RADIANT HEATING AND  
COOLING SYSTEMS

## SINGLE-STAGE SETPOINT CONTROLLER WITH FLOOR SENSOR

**TECHNICAL BULLETIN**

- A3041501 Single-stage Setpoint Controller with Floor Sensor

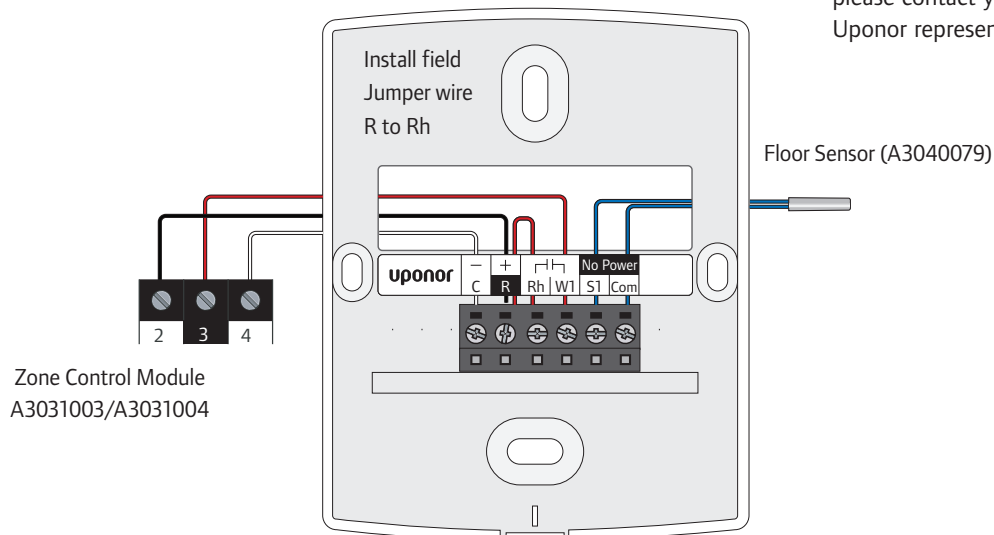
The thermostat will not power up and is unable to create a heat demand.

The wiring connections in the Thermostat Wiring section on page 9 of the Installation and Operation Manual are incorrect for the Zone Control Modules (A3031003/A3031004).

Follow the wiring schematic below to properly wire the thermostat.

Note that the Single-stage Setpoint Controller with Floor Sensor Installation and Operation Manual is being updated with the correct wiring schematic and the new literature will be included in all future product shipments.
